**PLANNED UNIT DEVELOPMENT,  
PLANNING APPROVAL &  
SUBDIVISION STAFF REPORT****Date: September 4, 2014**

<b><u>NAME</u></b>	Emmanuel Subdivision
<b><u>SUBDIVISION NAME</u></b>	Emmanuel Subdivision
<b><u>LOCATION</u></b>	1962, 2000 and 2008 Dr. Martin Luther King, Jr. Avenue (Northeast and Southeast corners of Dr. Martin Luther King Jr. Avenue, extending to the West side of Vine Street)
<b><u>CITY COUNCIL DISTRICT</u></b>	District 2
<b><u>PRESENT ZONING</u></b>	R-1, Single-Family Residential District
<b><u>AREA OF PROPERTY</u></b>	3 lots / 3.3 ± acres (Subdivision) 2 lots / 2.94 ± acres (PUD and Planning Approval)
<b><u>CONTEMPLATED USE</u></b>	Planning Approval to allow the expansion of an existing church school in a R-1, Single-Family Residential District, Planned Unit Development approval to allow multiple buildings on a single building site and off-site parking, and Subdivision approval to create three legal lots.
<b><u>TIME SCHEDULE FOR DEVELOPMENT</u></b>	Not specified.

# SITE PLAN

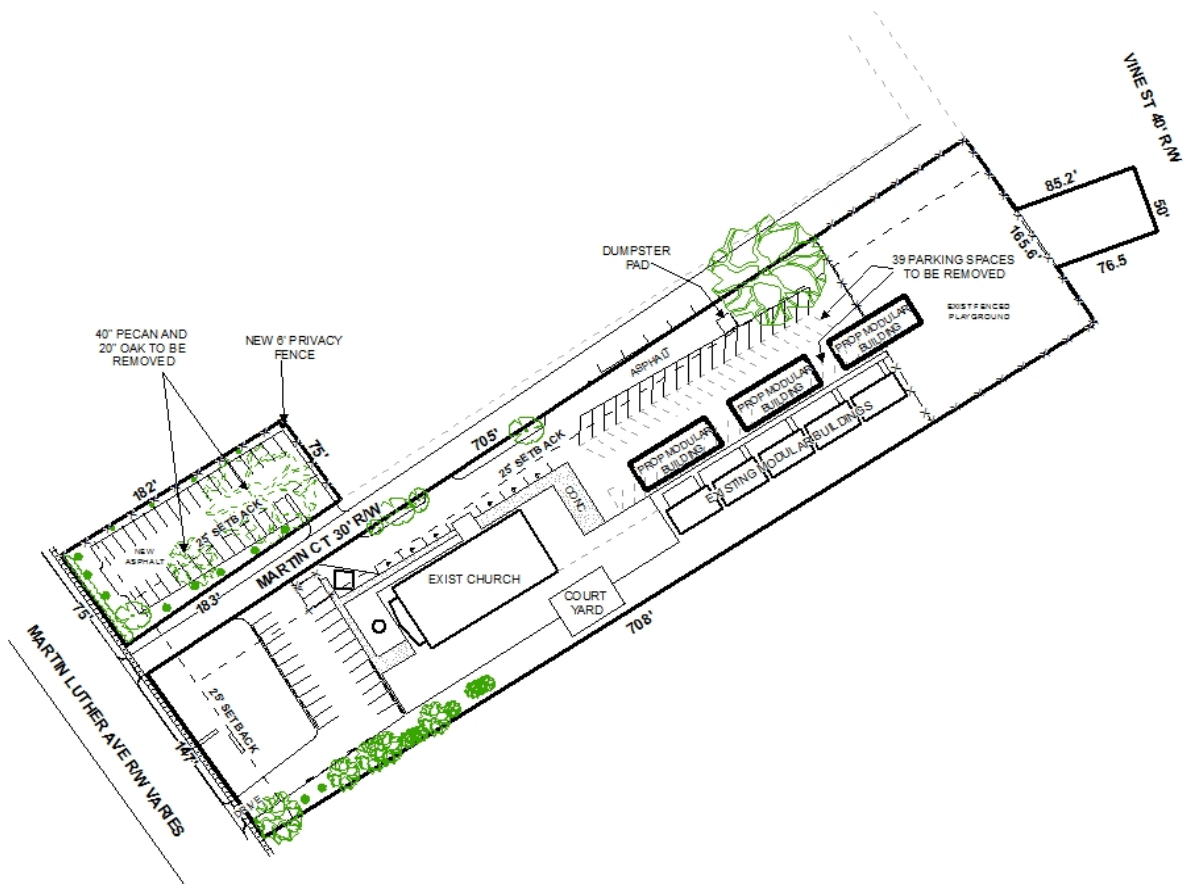
- 1. Include LOT 3 (Parcel D) on the PUD Site Plan and show the proposed site components.
- 2. Show the existing asphalt limits on Martin Ct. to the north end of LOT 1.

Further, as proposed, parking and access management would be of concern as the new buildings would eliminate some of the existing parking spaces and travel aisles; however, the applicant has proposed a 33-stall, off-site parking lot directly across Martin Court, on a separate lot.

The proposed Lot 1 has 2 existing curb-cuts to Dr. Martin Luther King, Jr. Avenue; 4 existing curb-cuts to Martin Court, one of which appears to be 250'± wide; and 1 existing curb-cut along Vine Street - however, Staff recommends this curb-cut be closed and access denied to this street. The site also has 1 existing curb-cut to Dr. Martin Luther King, Jr. Avenue for the proposed Lot 3 and applicant also proposes 1 new curb-cut for the proposed Lot 2 onto Martin Court. As a means of access management, notes should be placed on the revised site plan and plat stating that the existing curb-cut along Vine Street be closed and the proposed Lot 1 be denied access to this street and limited to a total of 5 curb-cuts. The proposed Lot 3 should be limited to the existing curb-cut and the proposed Lot 2 should be limited to the proposed curb-cut to Martin Court, with the size, design, and location of the new curb-cut, along with any changes to the existing curb-cuts to be approved by Traffic Engineering and conform to AASHTO standards. Staff recommends the applicant coordinate with Staff to revise the site layout as necessary to maximize onsite traffic flow, parking and ingress/egress along Martin Court.

It should be pointed out that the planned parking spaces on the proposed Lot 2 appear compliant in regards to stall and aisle dimensions; however, neither bumper stops nor curbing is illustrated on the site plan. The site currently has a total of 90 existing parking spaces; however, the applicant proposes to eliminate 39 spaces to be replaced with 33 new off-site spaces on an adjacent lot, which would give the site a total of only 84 spaces. As the primary use of this site is a religious institution, required parking is calculated at a ratio of 1 space per 4 seats and, as the site plan notes 400 seats within the sanctuary, 100 parking spaces would be required. As only 84 parking spaces are currently proposed, the applicant should revise the site layout to depict a compliant number of parking spaces in accordance with Section 64-6. of the Zoning Ordinance.

The site plan illustrates 5 parallel parking spaces within the existing right-of-way, which should be eliminated. Compliance with Traffic Engineering comments should also be depicted on the revised site plan.

In reference to tree and landscaping compliance, the proposed landscaping on the proposed Lot 2 is compliant in regards to trees and landscaping; however, the proposed 3' high hedge row should also be extended and illustrated along the frontage of Martin Court on the revised site plan. Landscaping data is also listed on the site plan for the proposed Lot 1; however, full compliance with the tree and landscaping requirements of the Zoning Ordinance will not be required until the time of development if the total gross floor area of the site is increased and/or decreased by at least 50% of the existing buildings' footprint.

The site plan also depicts a 6' high wooden privacy fence on the proposed Lot 2 to be used as a residential buffer, as the site is adjacent to R-1, Single-family Residential; however, the site plan should be revised to depict all proposed fencing not to exceed 3' in height within the 25' minimum building setbacks of Martin Court and Dr. Martin Luther King, Jr. Avenue.

The site plan illustrates an existing dumpster pad within the existing parking lot on the proposed Lot 1 and, as mentioned earlier in this report, Staff recommends revision of the site layout which may cause the relocation of the dumpster facilities. In the event the dumpster is relocated, the site plan would be revised to illustrate any proposed dumpster in compliance with Section 64-4.D.9. of the Zoning Ordinance. If the site layout can be revised to accommodate the existing dumpster, full compliance with Section 64-4.D.9. would not be required at this time; however, the applicant should still keep in mind the recently adopted Litter Ordinance which requires all existing dumpsters to be enclosed, per the standards of said Ordinance.

- 2) Coordination with Staff to revise the site layout as necessary to maximize onsite traffic flow and ingress/egress along Martin Court;
- 3) Revision of the site layout to illustrate a compliant number of parking spaces in accordance with Section 64-6. of the Zoning Ordinance;

- 4) Revision of the site layout to reflect compliance with Traffic Engineering comments;
- 5) Illustration of bumper stops or curbing for all new parking spaces;

- 6) Depiction of the 25' minimum building setback line on the site plan along Vine Street;
- 7) Illustration of a 3' high hedge row along Martin Court on the proposed Lot 2;

- 8) Placement of a note on the site plan stating that proposed privacy fencing is not to exceed 3' in height within the 25' minimum building setbacks of Martin Court and Dr. Martin Luther King, Jr. Avenue; and

# DETAIL SITE PLAN

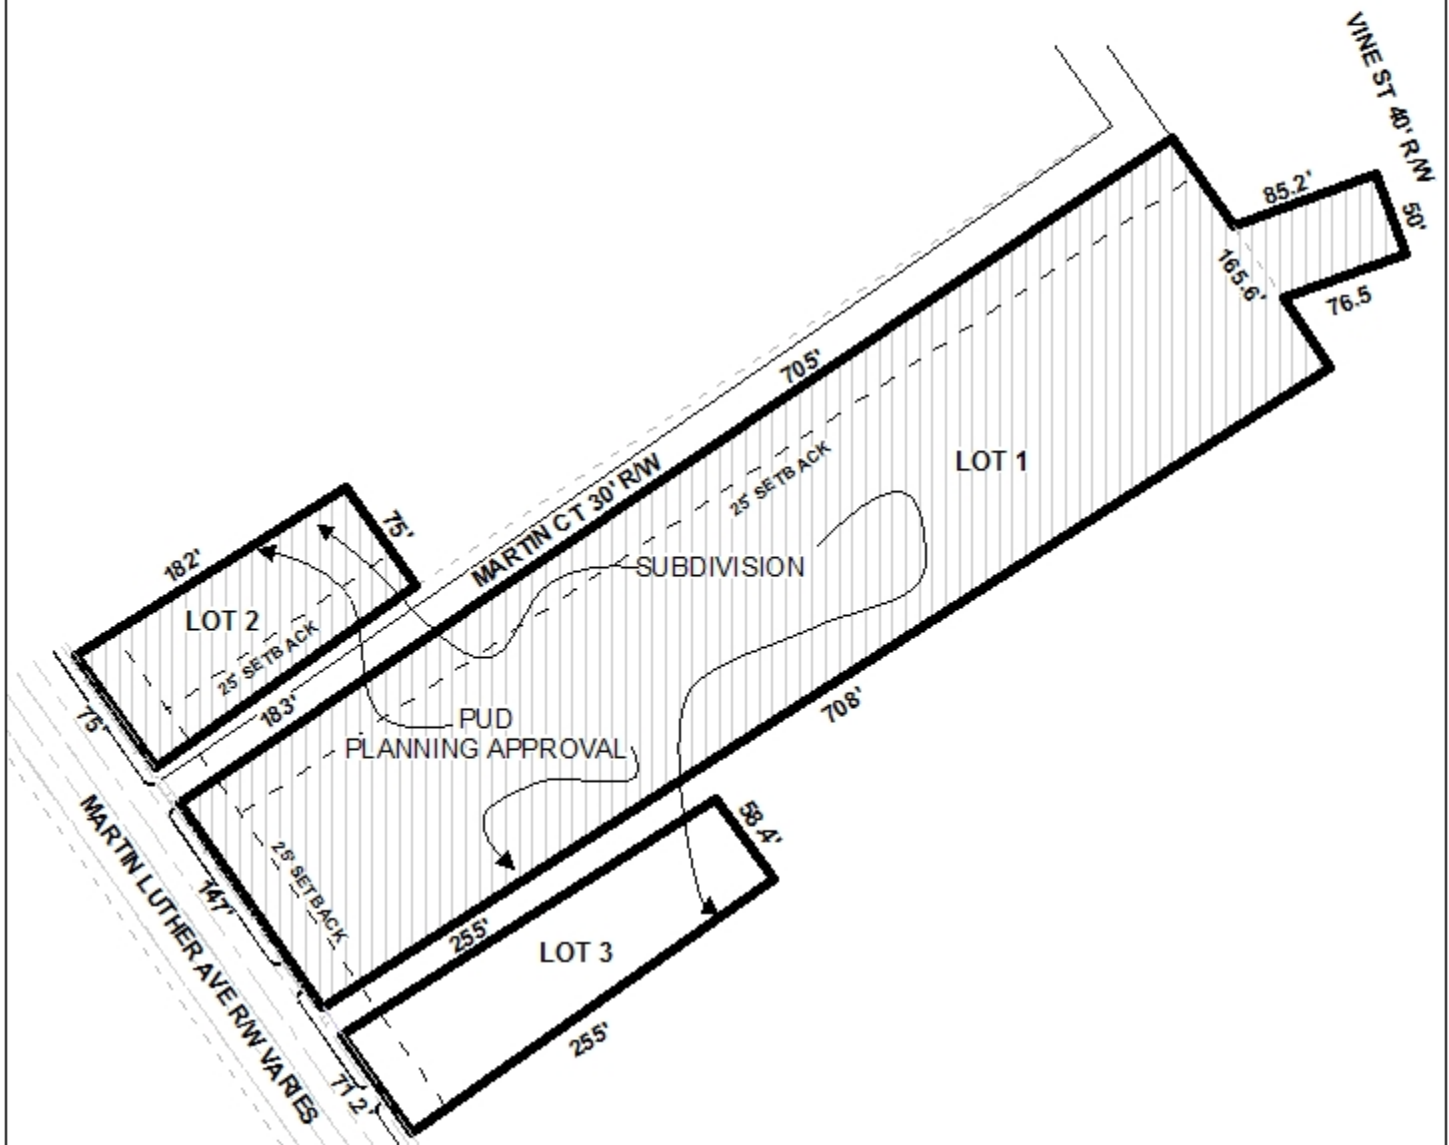
Driveway number, size, location and design to be approved by Traffic Engineering and conform to AASHTO standards. Lot 1 is denied access to Vine St and limited to a total of 5 curb cuts. Lot 2 and Lot 3 are each limited to one curb cut. For improved circulation on the site and increased parking area near the proposed modular buildings, the striping could be reconfigured with a one-way driving lane and angled parking on either side (adjacent to the buildings, and adjacent to the right-of-way). The five parallel spaces should be eliminated and a grassed area provided between the roadway of Martin Ct and the new parking spaces. There is an additional power pole that is not shown in the vicinity of the 42" live oak; ensure that the utility details are accurate if this will impact the site layout.
